**REDLINE**

## **Teanaway Solar Reserve**

# **Conditional Use Permit Application Supplement and Expanded SEPA Checklist Supplement**

**FEBRUARY 2010**

**FIGURE 10**  
**Designated Critical Areas: Erosion-Prone Soils and Geologic Hazards**  
 Teanaway Solar Reserve  
 Kittitas County, Washington

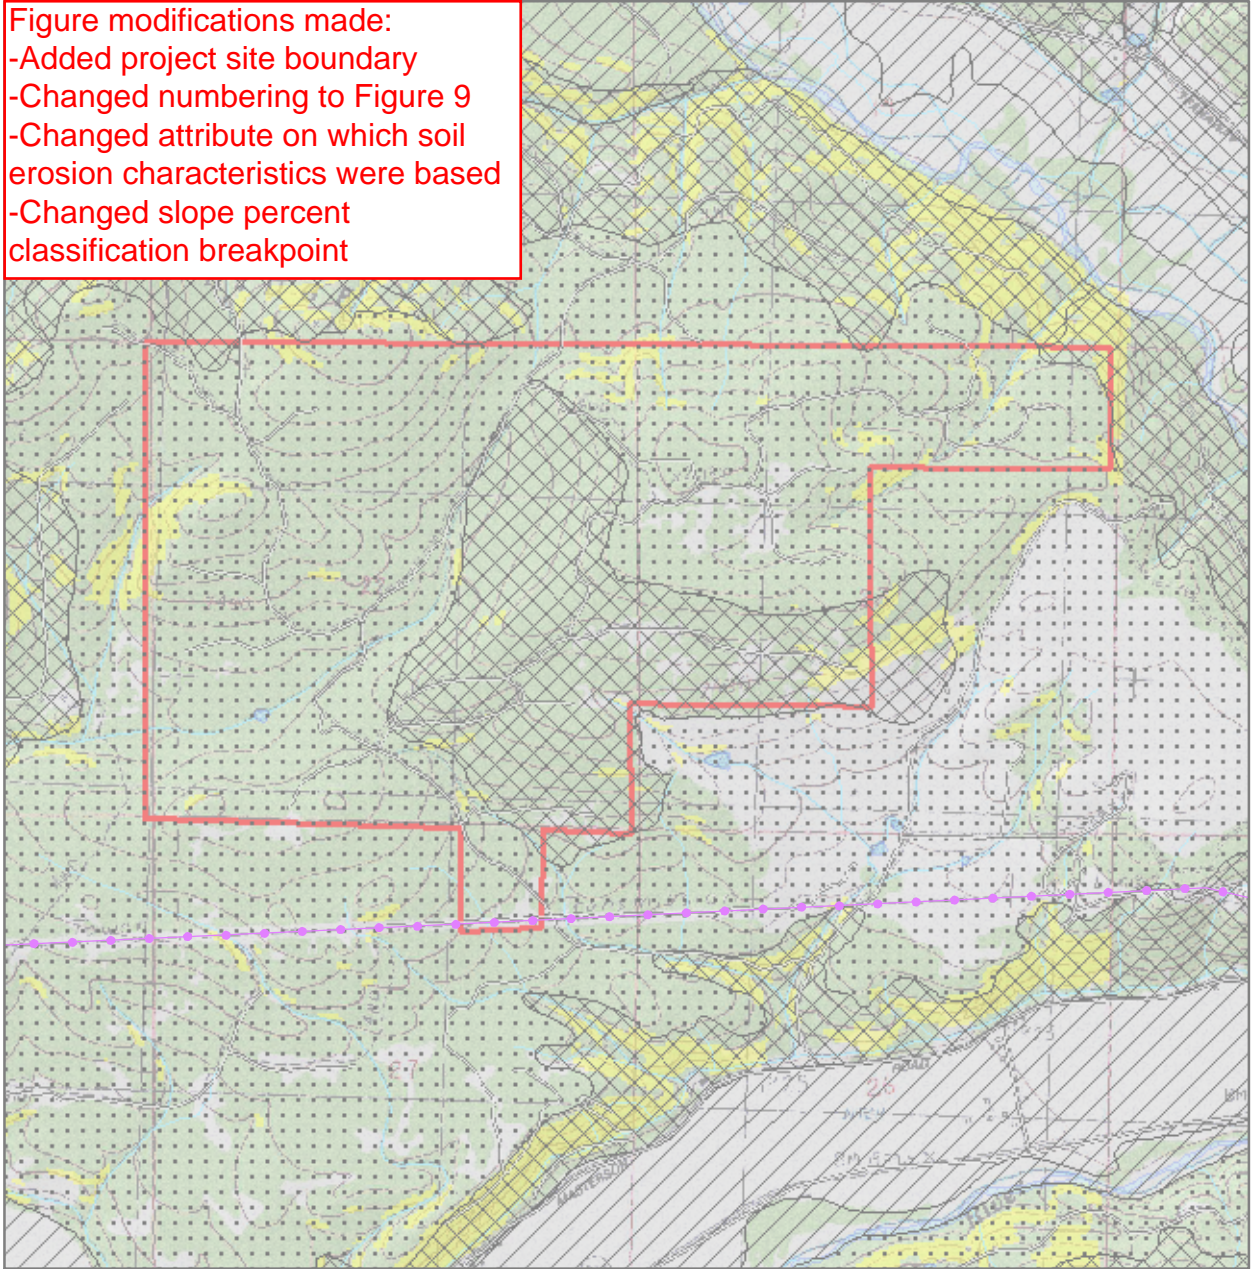
Figure modifications made:  
 -Added project site boundary  
 -Changed numbering to Figure 9  
 -Changed attribute on which soil erosion characteristics were based  
 -Changed slope percent classification breakpoint

**FIGURE 1**  
**ZVI Analysis Zone Points**  
 Teanaway Solar Reserve  
 Kittitas County, Washington

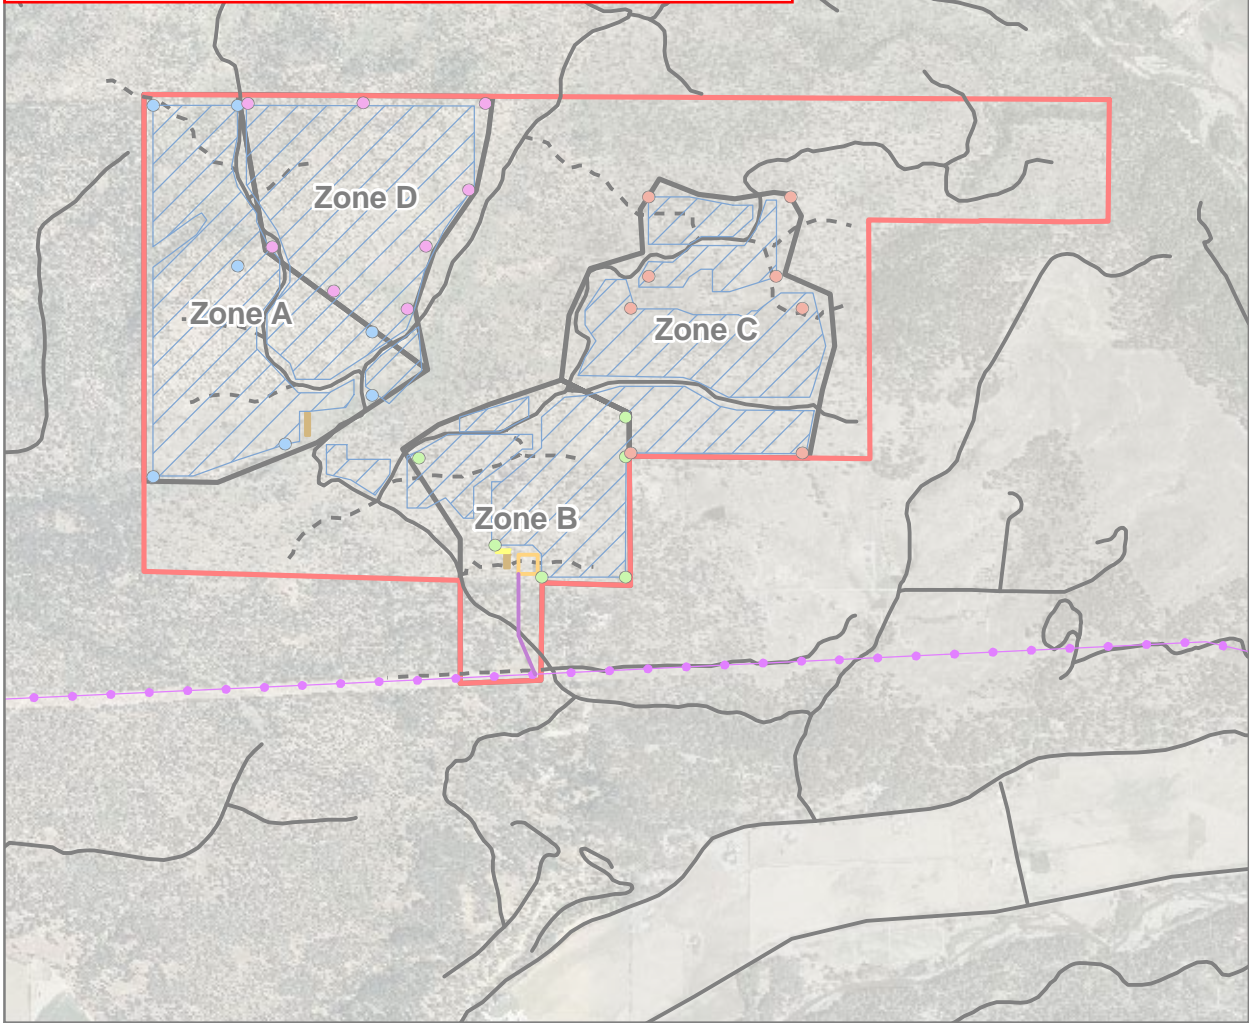
Figure modifications made:  
 -Removed classification of roads based on field notes  
 -Updated site layout  
 -Changed ZVI Zones to reflect current layout  
 -Added analysis points  
 -Changed to 11x17 layout
